\*\*\*MODIFICATIONS\*\*\*

EAGLE - Model 500

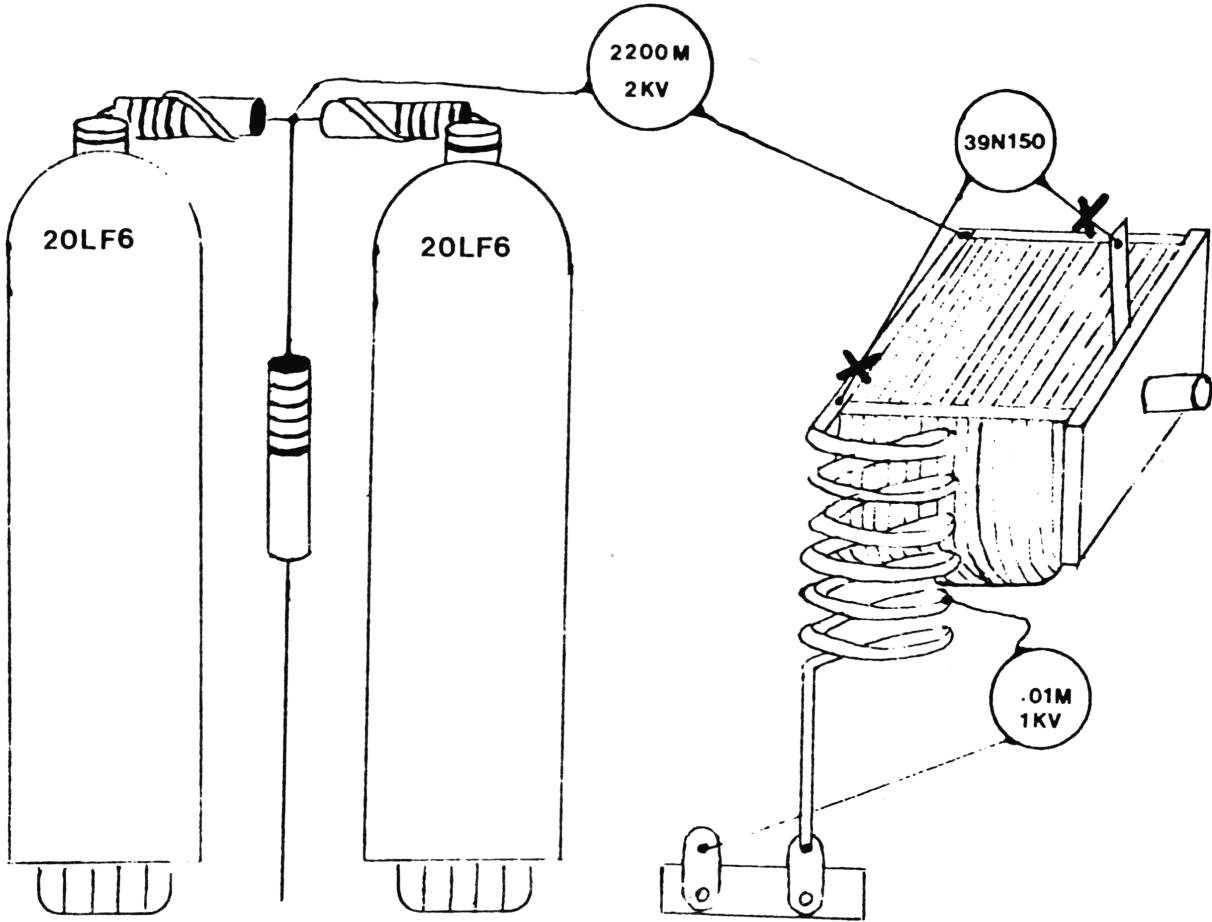
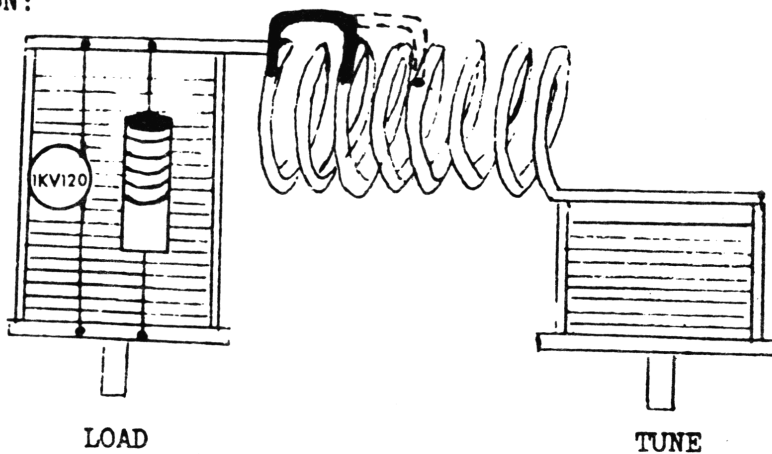
DRIVER MODIFICATION:

Factory Issue as depicted above. To modify, remove capacitor (39N150) across Drive Control. Cut as indicated by "X's".

OUTPUT MODIFICATION:

Factory Issue as depicted above. To modify, move strap on coil between "Load" and "Tune" from third turn (as per factory issue) to fifth turn (as indicated above).
